<b>Location:</b>	Surface Parking lot on 0 Tucker Street (APN 047 -5596-005-00) (see map on reverse)
<b>Proposal:</b>	Construction of a one-story, 2,200 square-foot commercial building, drive-through, and associated site improvements.
<b>Applicant:</b>	Durant Commercial, LLC
<b>Phone Number:</b>	Frank Coda / Green Farrow (914) 393-8293
<b>Owner:</b>	Durant Commercial, LLC
<b>General Plan:</b>	Community Commercial
<b>Zoning:</b>	CC-2 Community Commercial-2 Zone / RM-2 Mixed Housing Types Residential-2 Zone
<b>Environmental Determination:</b>	Categorically Exempt under California Environmental Quality Act (CEQA) Guidelines Section 15303, New construction of small structures; 15183, Projects consistent with community plan, general plan or zoning
<b>Historic Status:</b>	Not a Potential Designated Historic Property (PDHP)
<b>City Council District:</b>	7
<b>Date Filed:</b>	May 11, 2020
<b>Action to be Taken:</b>	Review proposed design

**SUMMARY**

Staff requests the Design Review Committee review the proposed site plan options for a one-story Starbucks café building and drive-through. The proposed 2,200 square-foot commercial building will be on a 19,904 square-foot parcel, currently use

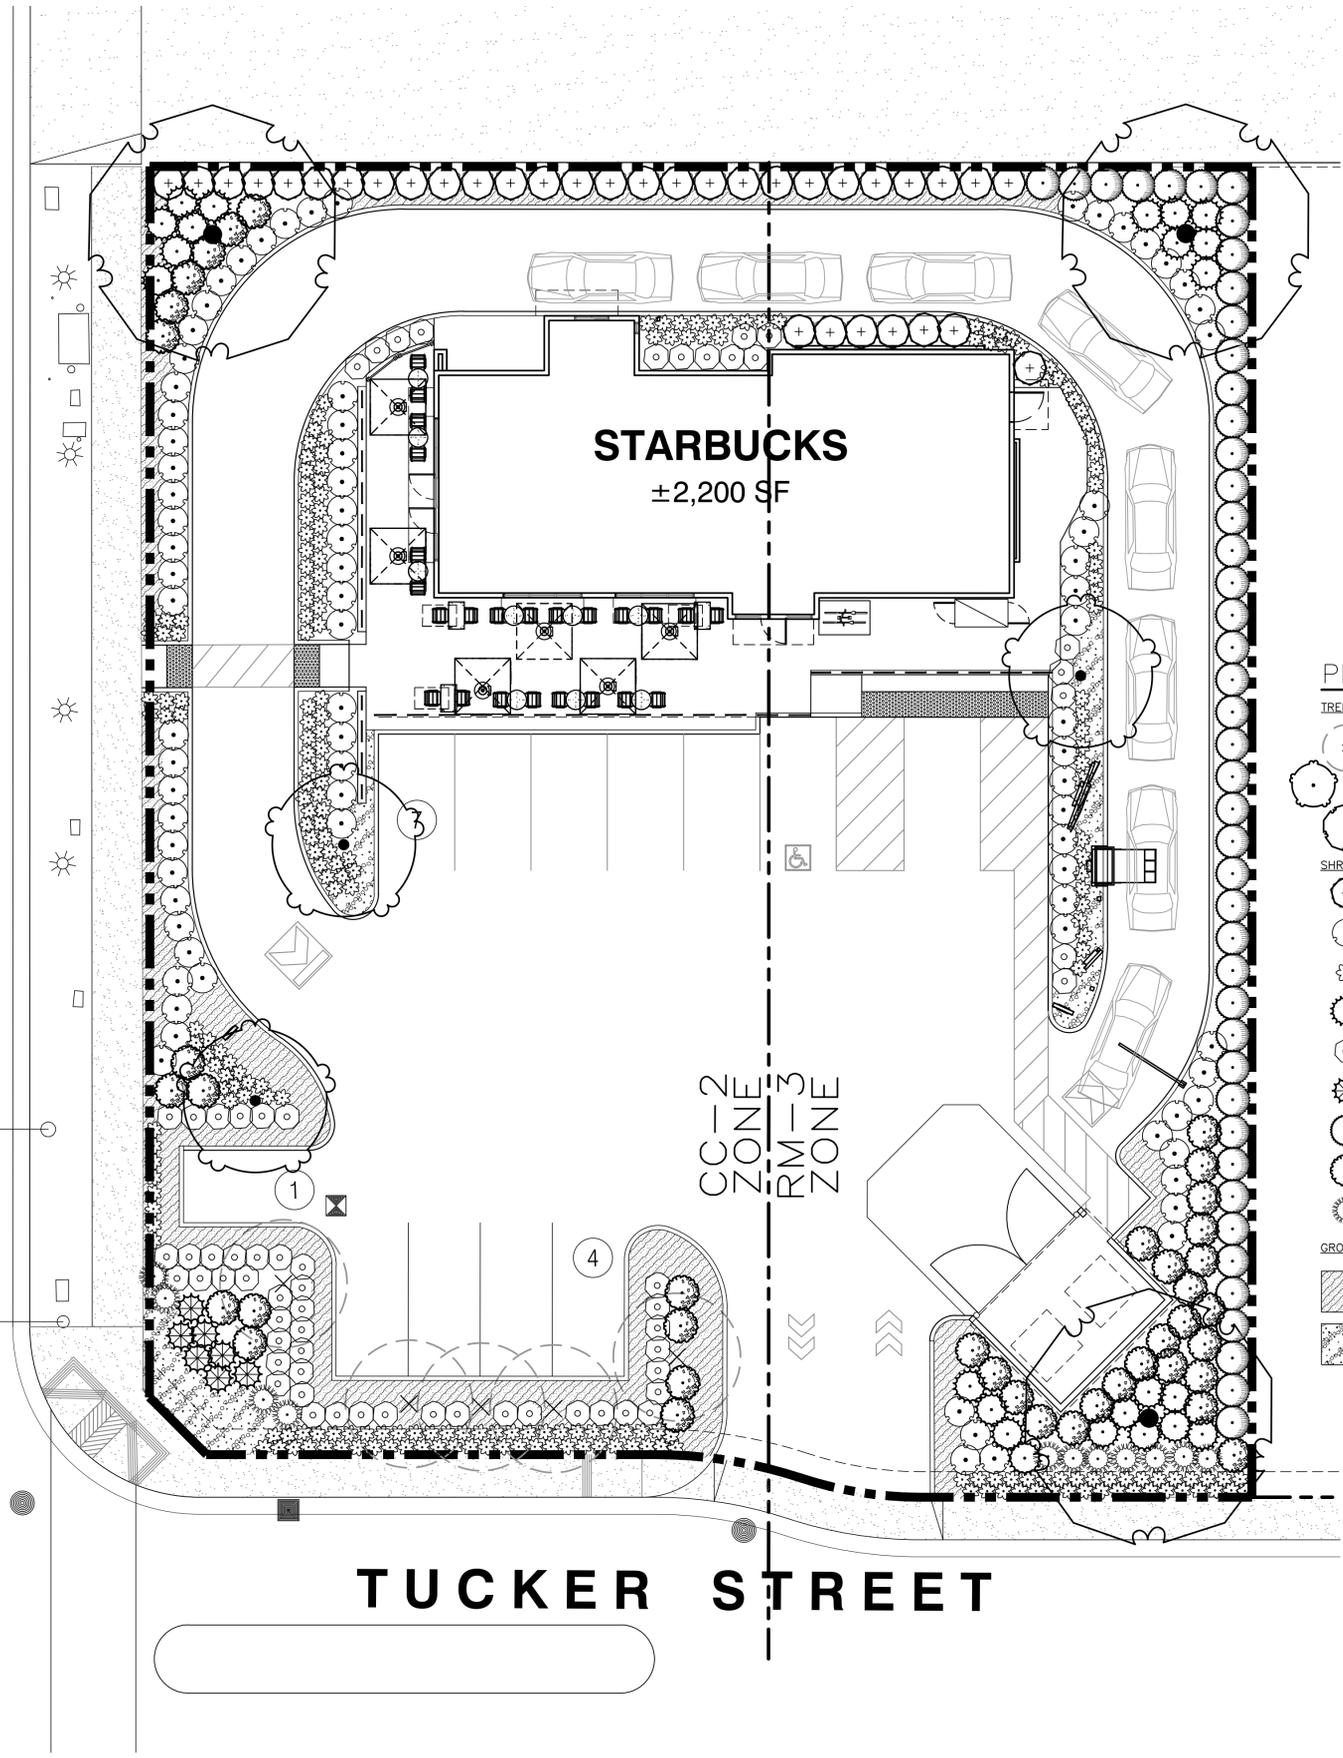
- **Option #1** would site the proposed building perpendicular to International Boulevard near the northern property line and have significant window area on the front façade. The ordering screen would be located behind the building, approximately 20 feet from the multi-family development behind the lot. The applicant would be required to provide a “sound isolation tube” in that area of the driveway around the ordering screen, so noise from the ordering would not disturb these neighbors. The food and drinks would be serviced on the north side of the building. Ten parking spaces would be located south of the building adjacent to the Tucker Street entrance.

Despite its circulation advantages, staff cannot recommend Option #2 without a redesign of the building to have a significant window presence facing International Boulevard. The current building design for Option #2 would create a nearly windowless front façade and completely orient the building toward the rear parking lot. Such a building design and orientation would deactivate the street edge, create security issues by removing “eyes on the street”, remove the connection between the public and private realm, and provide a visually substandard façade-facing façade on one of the City’s busiest transportation corridors. If on the other hand the Option #2 site plan could be accommodated with a significant building window presence facing International Boulevard, it could result in a number of design advantages, including maximizing frontage on International Boulevard, drive-through queuing capacity, and distance from the ordering area to the residential development behind the site. This building redesign would require moving the floor area devoted to storage, counter service, and food and drink preparation to the north end of the building, which would allow windows on the south end to face International Boulevard by freeing up customer space adjacent to the front façade. However, the applicant has stated that this is not practical for the café because of the distance it would require baristas working at the drive-through window to walk to the drink preparation area.

Therefore, of the two site plans presented, staff supports Option #1, which would provide windows facing the street and outdoor seating viewable from International Boulevard. These features provide a better façade treatment and a greater connection between the street and the activities associated with a café.

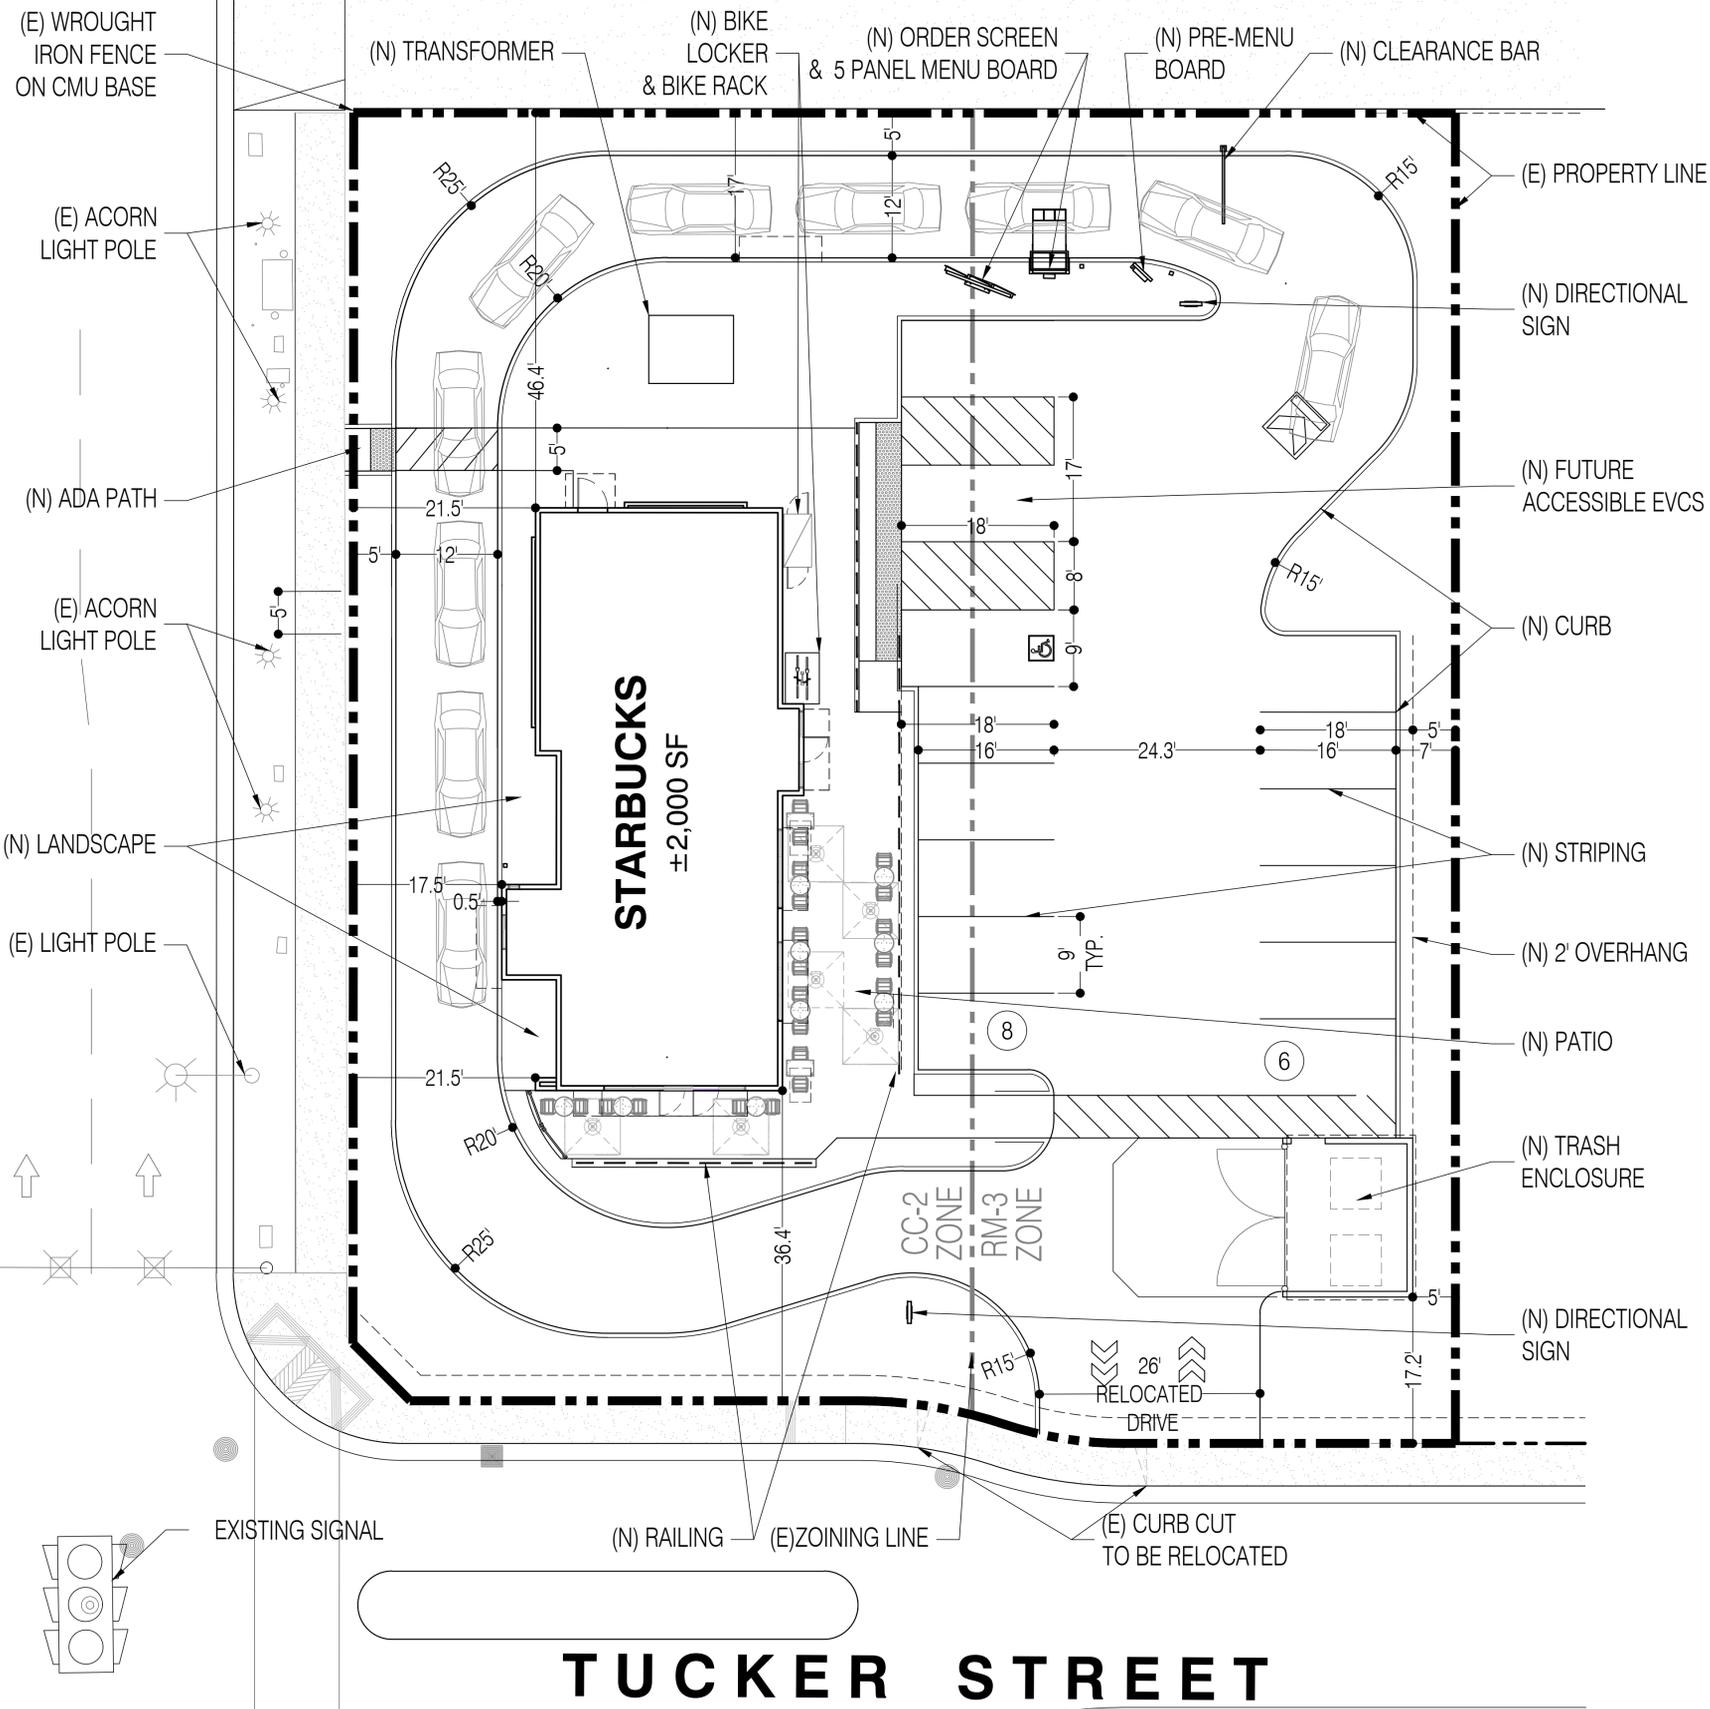
- **Option #2** would site the proposed building parallel to International Boulevard towards the center of the property. The front façade would have limited window space facing International Boulevard. According to the applicant, this creates the most efficient internal floor plan; however, it also orients the building toward the parking lot. This issue is further discussed in the “Key Issues and Impacts” section of the report. The location of the ordering screen would be on the north side of the building further away from the residential properties and not require a “sound isolation tube”. The drinks and food would be served in the front of the building adjacent to International Boulevard. Parking would be behind the building. The drive-through lane would accommodate ten cars, with more cars potentially accommodated that spill over into the ten-car parking lot.
